**MEMORANDUM**  
**February 3, 2016**

**TO:** Landmarks Board

**SUBJECT:** Public Hearing and consideration of a Landmark Alteration Certificate application for changes to the south face of the landmarked St. Gertrude's Academy including the construction of six balconies and modifying windows to door openings, per Section 9-11-18 of the Boulder Revised Code (HIS2015-00313).

1. Site: 970 Aurora Ave.
2. Zoning: RL-1 (Residential Low-1)
3. Owner: Academy Equities, LLC
4. Applicant: Jonas DiCaprio, Design Platform
5. Site Area: 104,867 sq. ft.
6. Building Area: 41,670 sq. ft. (approx.)
7. Date of Construction: 1892

Figure 10. Proposed plan for balcony on the 3<sup>rd</sup> floor, 2015.

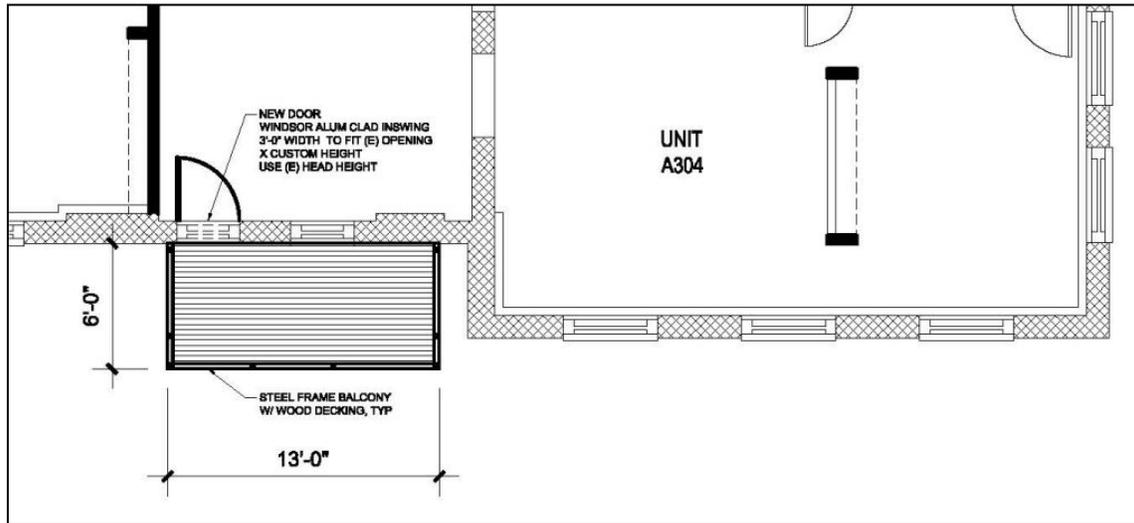
Six window openings on this elevation are shown to be enlarged vertically to accommodate aluminum clad in-swing door 3 ft. in width to fit the opening of the window. Plans note that the existing 3 ft. width and head height will remain; the sandstone sill and brick below each window is to be removed.

Figure 11. Proposed plan for balcony for Unit A102 on the 1<sup>st</sup> floor, 2015.

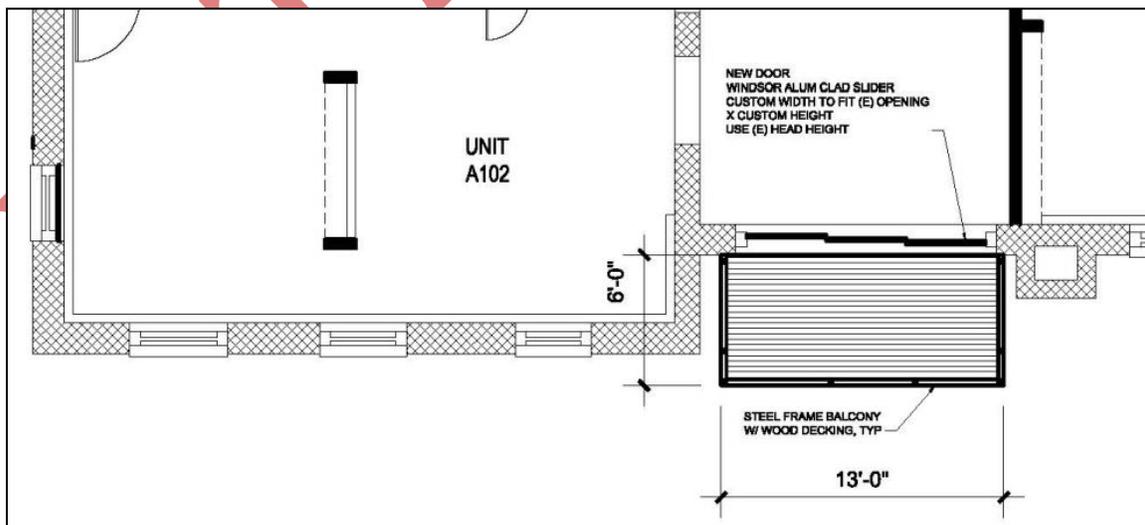
The proposed balcony on the west unit of the second floor (Unit A102) is shown to be fitted with a sliding glass door rather than a single door. Unlike the other balconies where one window will be retrofitted for a door, plans for this unit show the removal of three windows to be replaced with an aluminum clad sliding door to fit the width of the existing opening (See Figure 8).

Proposed Modifications, South Elevation, 2015.

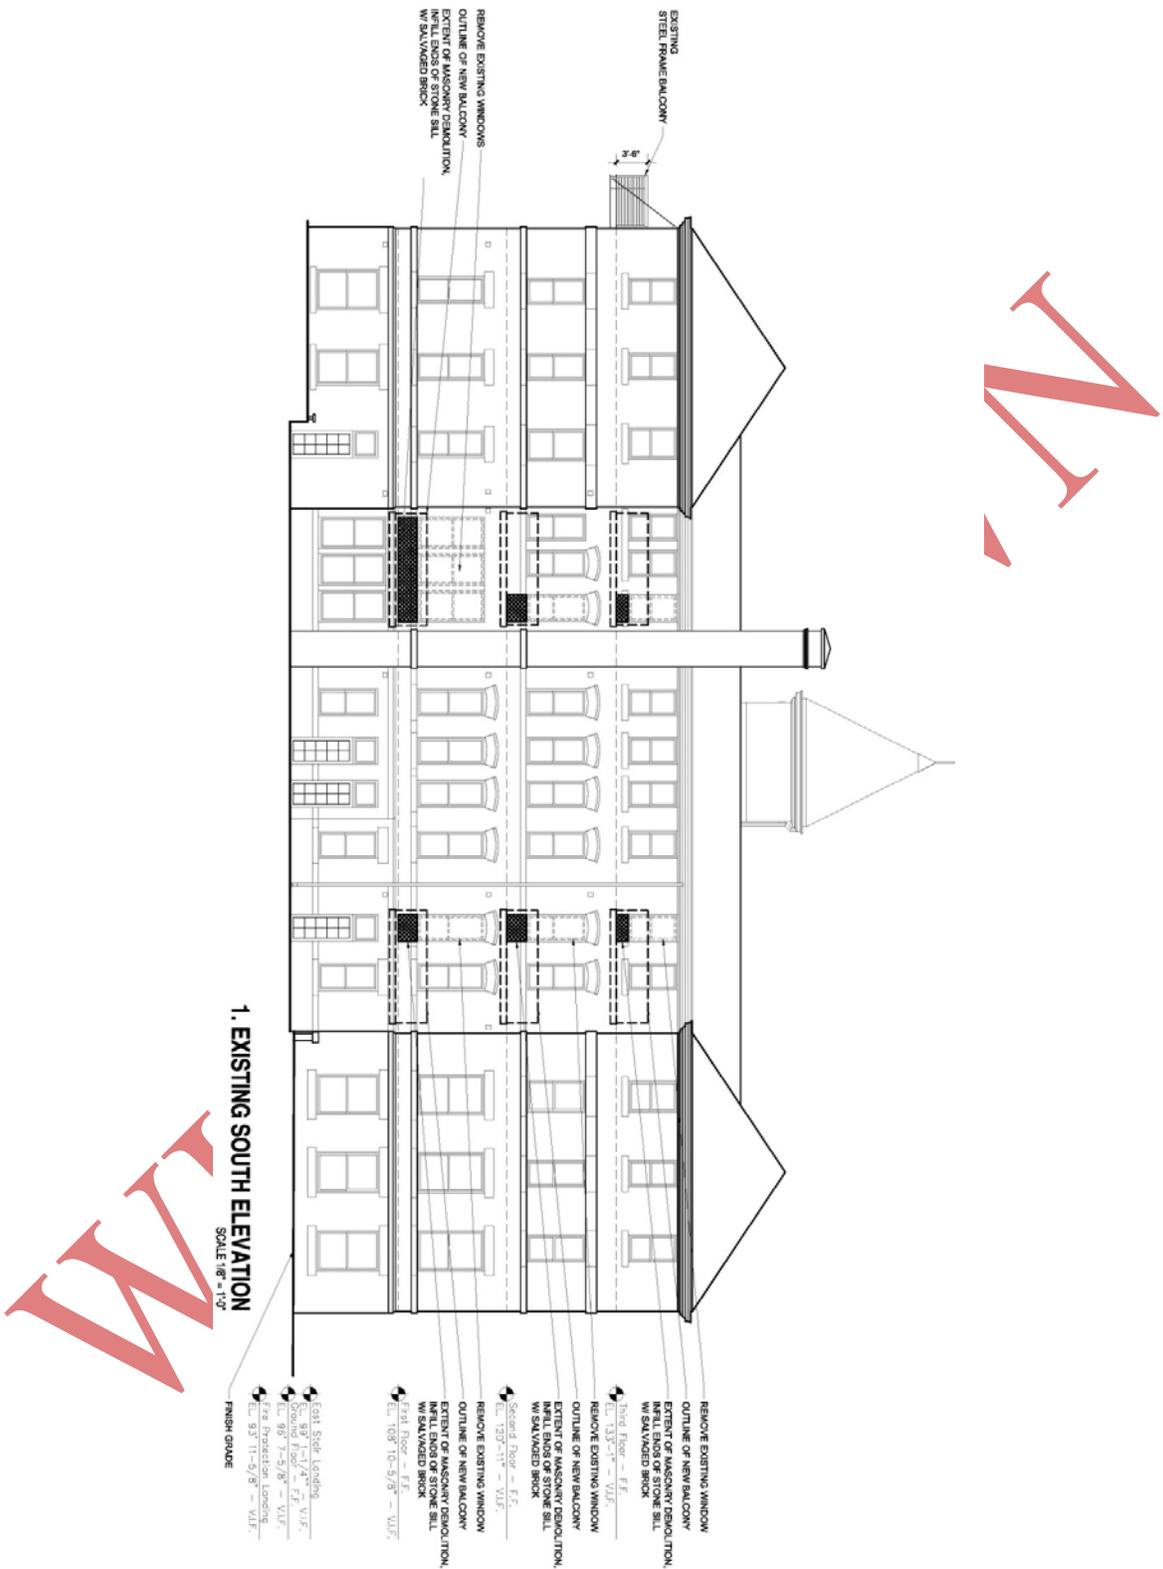
<i>Guideline</i>	<i>Analysis</i>	<i>Conforms?</i>
.1	<i>Retain and preserve existing historic windows, including their functional and decorative features, such as frames, glass, sashes, muntins, sills, heads, moldings, surrounds and hardware. Because windows near the façade are particularly critical to the character of historic buildings, their protection may supersede the protection of historic windows elsewhere. In some cases, it may be appropriate to use window elements from rear or side elevations to repair those on the front.</i>	Proposal requires the removal of eight historic windows on a Secondary elevation. The proposal also calls for the alteration of six original window openings, including removal of the existing sandstone sills and the masonry beneath each opening.	No
.2	<i>Preserve original window locations; do not move windows from their historic placement.</i>	While doors are proposed be placed in original window locations in terms of width, masonry removal beneath the window will be required to create an opening tall enough for a door.	No

.7	<p><i>The historic significance of the windows proposed for replacement must also be assessed. In general, the more significant a window is to the building as a whole, the less likely that a retrofit or replacement will be appropriate. The appropriateness of a window replacement will be determined, in part, based upon characterization of the window as either 'Very Historically Important', 'Historically Important', or 'Non-Historic' (See Definitions).</i></p>	<p>Staff considers the windows on the south elevation to be Historically Important, as they are have "retained integrity from the period of significance and [are] an integral part of the historic design or is essential to the understanding of the architectural type or style."</p> <p>Staff considers the original window openings with stone sills and arched lintels to be Historically Important.</p>	No
.10	<p><i>If, through the Window &amp; Door Application &amp; Survey, it is determined the window may be</i></p>	<p>Proposal is to make window openings larger to accommodate doors.</p>	No

<i>replaced (Class III &amp; IV), the window opening itself should be carefully preserved. It should not be made larger or smaller to accommodate a differently sized window.</i>		
.11	<i>If, through the Window &amp; Door Application &amp; Survey, it is determined the window may be replaced (Class III &amp; IV), the same material as was the original is most appropriate; however, other materials may be considered if the operation, dimension, profile, durability, and finish are the same. Synthetic materials are generally inappropriate. Synthetic materials rarely duplicate the surface texture, reflective and detail qualities of original materials.</i>	Aluminum clad doors are proposed to replace the existing windows.	No

- Staff recommends that the Landmark Board deny the application and suggests the applicant to modify the design to retain the historic windows and window openings and explore the possibility of placing balconies on a less-visible elevation of the building.

#### 4. PROPOSED SECTION-ELEVATION

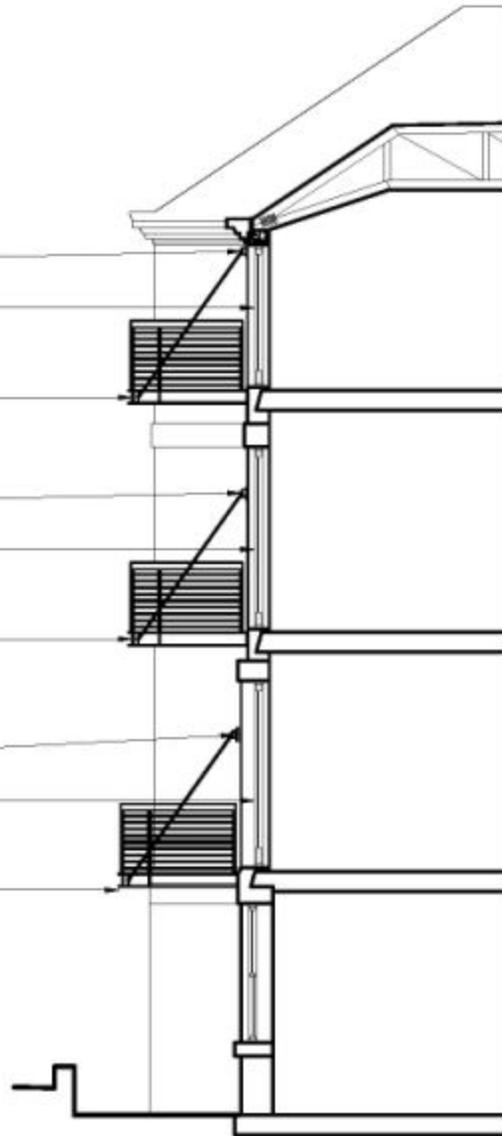
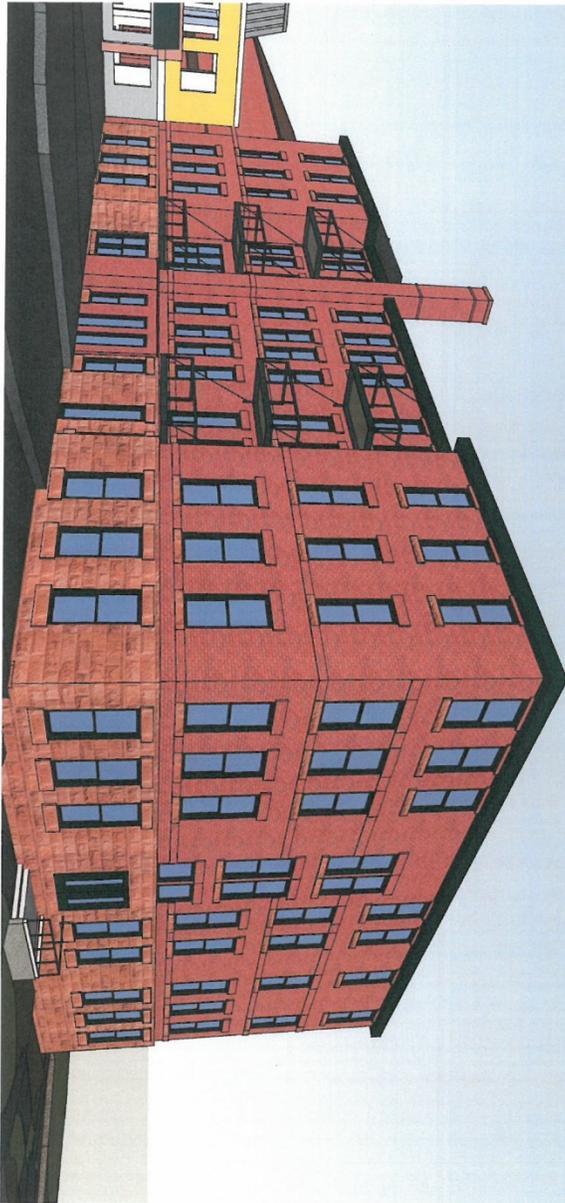
The balconies are shown to measure 13 ft. wide by 6 ft. long, with 3'6" railings. Proposed materials include steel frames with wood decking. Clevis connections, cables attaching the outer corners of the balconies to the masonry, are shown to secure the projecting balconies.

<i>balconies are appropriate only if recreating a documented historic element.</i>	east, and its proximity to the current primary entrance to the building, staff considers the south portion to be a Secondary elevation. Balconies are not a documented historic feature or the Mt. St. Gertrude Academy.	
.2	<i>Integrate the roof deck or balcony into the structure either by setting it into the building or by incorporating it into the roof structure.</i>	Balconies are not integrated into the structure or roof.	<b>No</b>
.3	<i>Avoid cantilevered projections from the building, and use appropriately scaled brackets or supports.</i>	Proposed balconies are cantilevered. Clevis connection (cable) is shown to support the balcony.	<b>No</b>
.4	<i>While current code requirements must be met, new railings should be as close as possible to historic heights. In addition, sensitive design may give the appearance of the lower railing heights found on historic structures.</i>	Plans show proposed balconies railings to be 3'6" tall. Proposed cantilevered steel frame balcony design is not based on a historic precedent.	<b>Maybe</b>
